**Response to Peer Review of: Ricardo  
Computer Simulation of Light-Duty  
Vehicle Technologies for Greenhouse  
Gas Emission Reduction in the  
2020-2025 Timeframe**

Assessment and Standards Division  
Office of Transportation and Air Quality  
U.S. Environmental Protection Agency

Prepared for EPA by  
Ricardo, Inc.  
and  
Systems Research and Applications Corporation (SRA)  
EPA Contract No. EP-C-11-007  
Work Assignment No. 0-12

Table 1: Response to Individual Peer Review Comments

Figure 19: BSFC over the engine operating envelope, CR 9.7:1.

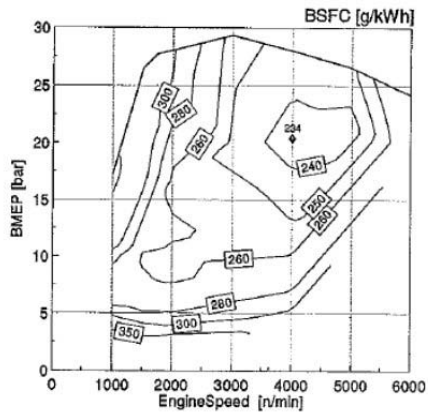
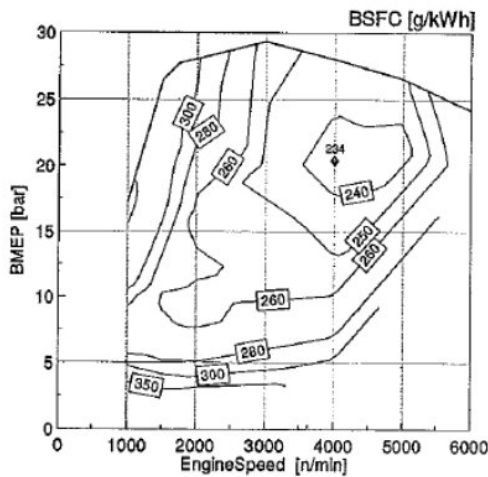
Other Comments	Stoichiometric DI Turbo Engine	280	The foregoing table indicates several significant issues: 2. The turbocharger response time for the Mahle engine is 2.5 seconds, whereas Ricardo assumed a time constant of 1.5 seconds. Such turbocharger delays are expected to result in significant driveability issues for engines that are downsized approximately 50%. (see Exhibit 7)	See revised section 4.1.3.	4.1.3

On the other hand, the Mahle engine appeared to be directly applicable, since it had a peak BMEP of 30 bar and used series-sequential turbocharging (Ref 3). Since Reference 3 provided the BSFC map for this engine, shown below, it is not clear why the Ricardo report could not have shown this map, or a map derived from this one, and then described how it was derived and/or combined with other maps to provide the model used in the report.

Figure 5-23. Estimated power loss in a deep-groove ball bearing

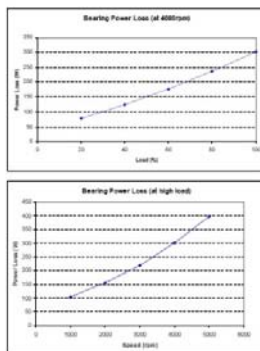
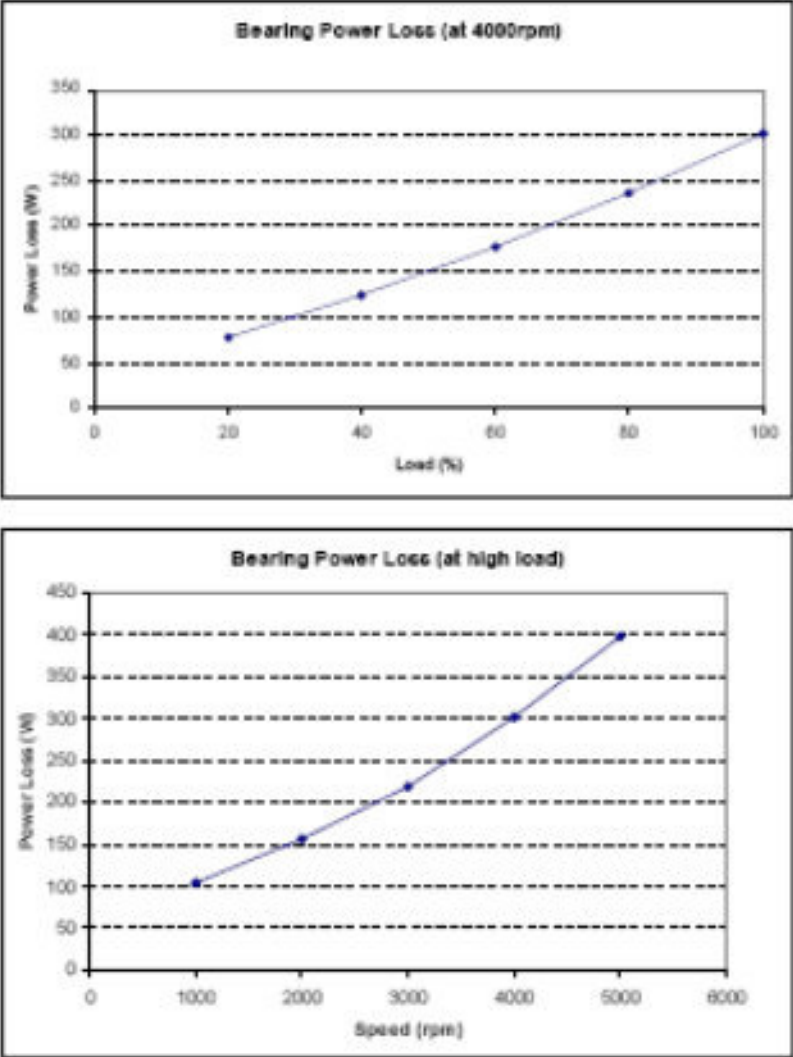
- Bearing and seal losses have a greater effect on efficiency at light loads than at heavy loads. The report did not describe how these losses were incorporated in the model. In contrast to the lack of descriptions of details in the report, Reference 4, as an example, provided the following map of bearing losses in a transmission as a function of shaft diameter and speed. Similar details for the relevant aspects of the transmission models in this report would have been expected.

Fig. 3.18. 2004 Prius motor efficiency contour map.

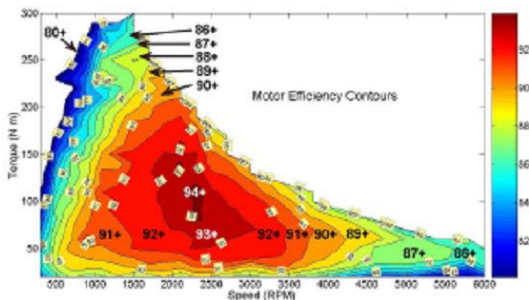
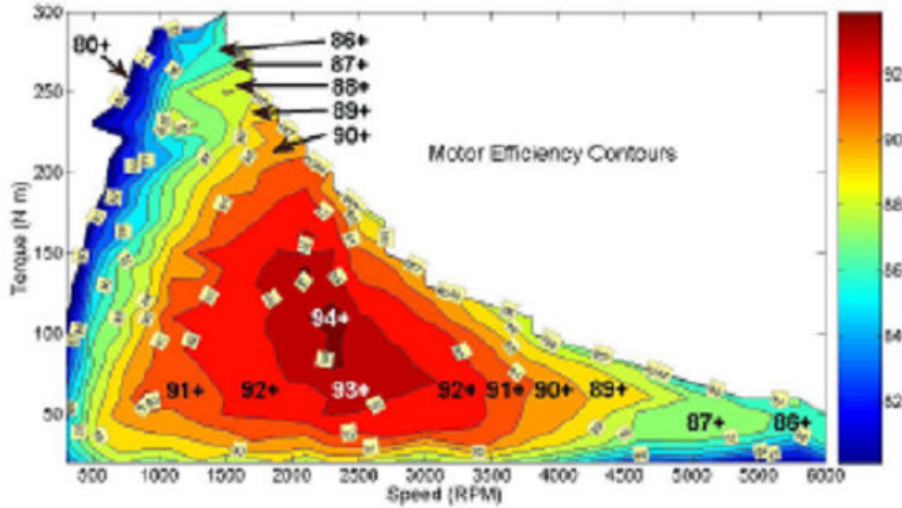
In contrast, as an example, Reference 6 provided a detailed motor efficiency map, shown below, as well as efficiency maps of other key components of the Prius hybrid vehicle. Similar maps for all hybrid subsystems would be expected in this report.

Figure 3-6: Electric Water Pump Machine & Air Conditioning Drive Efficiency

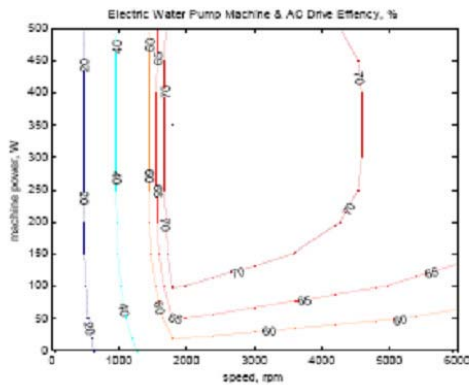
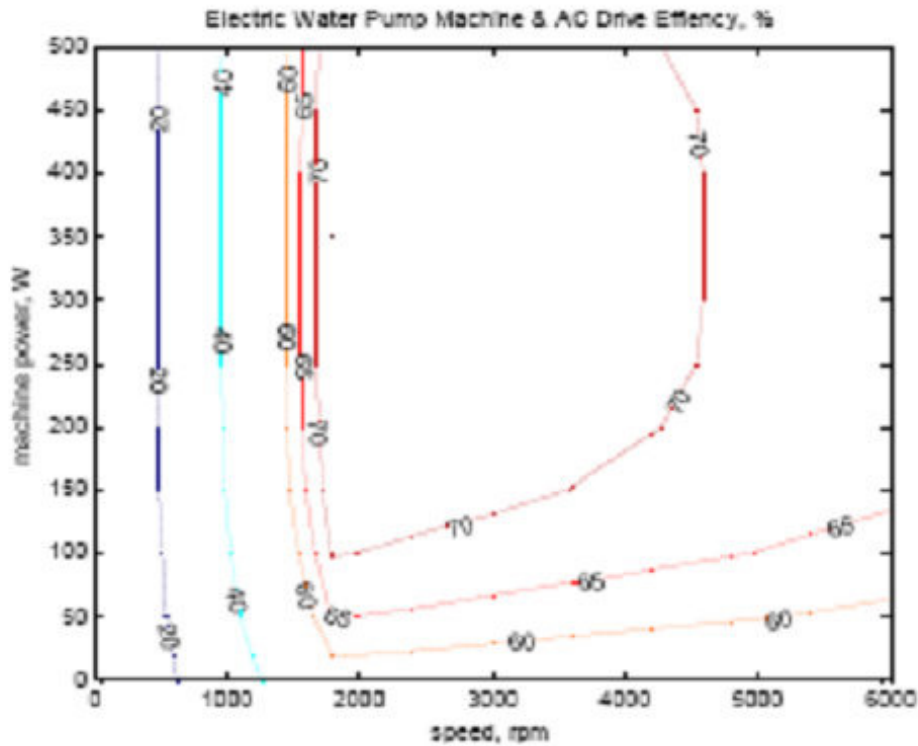
The accessory loads vs. engine speed for the conventional belt driven accessories were apparently removed from the engine when electric accessories were applied. However, the conventional accessory loads as well as the alternator loads/battery loads for the electric accessories were not provided.

In contrast, as an example, Reference 4 provided the following map of an electric water pump and AC compressor drive efficiency. Similar maps for all accessory models would be expected in this report.

**Figure 6.1: Comparison of CVT and optimized DCT gear ratios over drive cycle.**

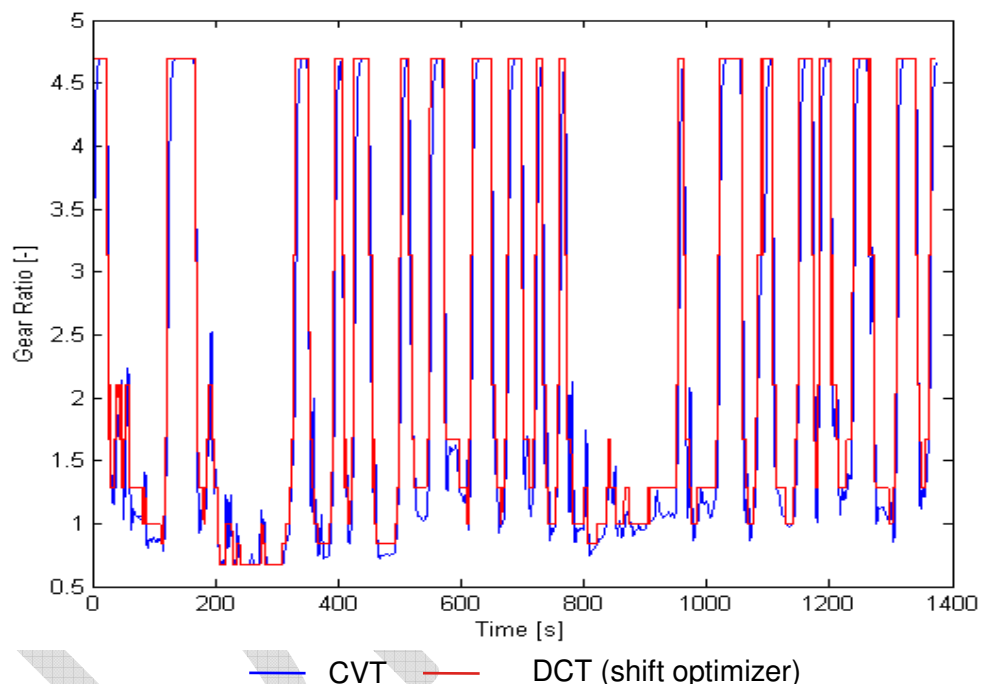
Simulation methodology	Transmission optimization	207	A transmission shift optimization strategy is presented in the report and the results are shown in Figure 6.1 (page 28). This figure shows very frequent shifting, especially for 4th, 5th and 6th gears.	See revised text in section 6.4 detailing comparison of optimized shifting to baseline production vehicles.	6.4
Simulation methodology	Transmission optimization	208	Issue: Optimized shift strategies of the type used by Ricardo have been previously evaluated and found to provide customer complaints of "shift busyness". Customers are likely to reject such a shift strategy.	See revised text in section 6.4 detailing comparison of optimized shifting to baseline production vehicles.	6.4
Recommendations		242	Recommendation: The detailed assumptions showing how the benefits of dry sump, improved component efficiency, improved kinematic design, super finish, and advanced driveline lubricants were added to the transmission maps should be added to the report before it is released.	See revisions to section 6.4 in the final report.	6.4

A transmission shift optimization strategy is presented in the report and the results are shown in Figure 6.1 (page 28). This figure shows very frequent shifting, especially for 4<sup>th</sup>, 5<sup>th</sup> and 6<sup>th</sup> gears.
